Concord Middle School Value Management Log Poll Results

9/14/2022

The following slides summarize the Value Management polling completed via a Google Form between Monday, 9/12/22 and Wednesday, 9/14/22 by all 13 Voting Members of the Concord Middle School Building Committee.

Item # 78: Eliminate entry concrete planter, add metal picket fence rail for fall protection, concrete retaining wall to remain (-12,832).

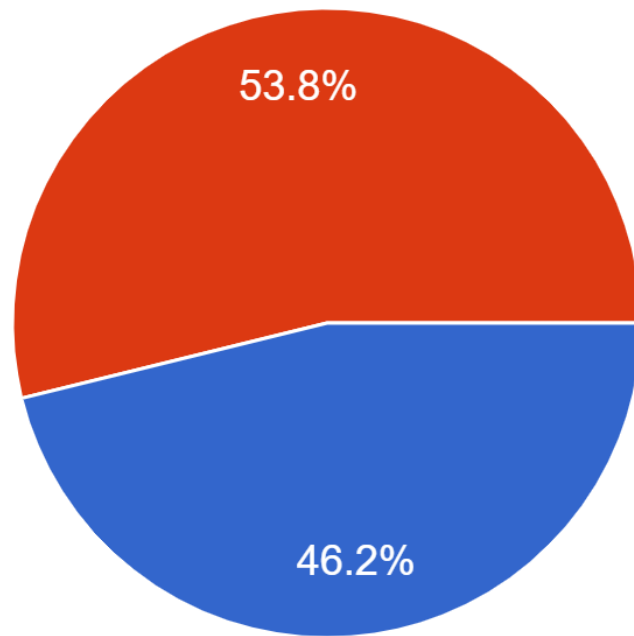
- A \$13,000 concrete planter?
- Please explain to Committee and discuss

Item # 80: Remove bevel at CMU exterior walls (-61,251).

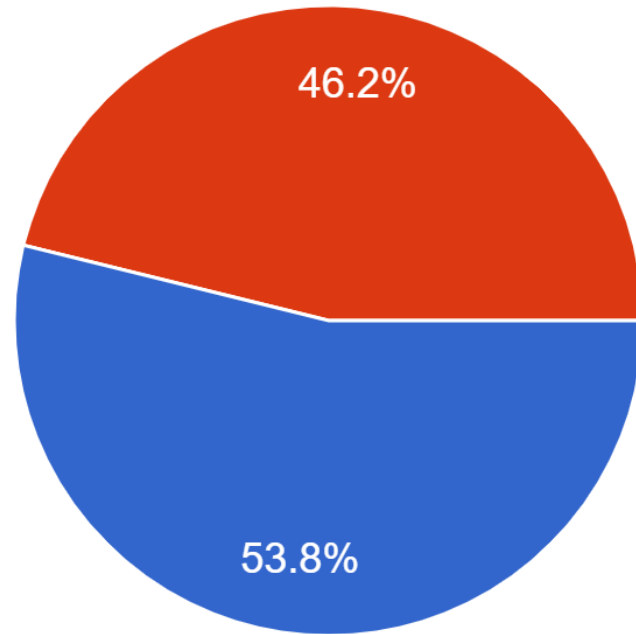
- Need more info
- Nobody will notice or care
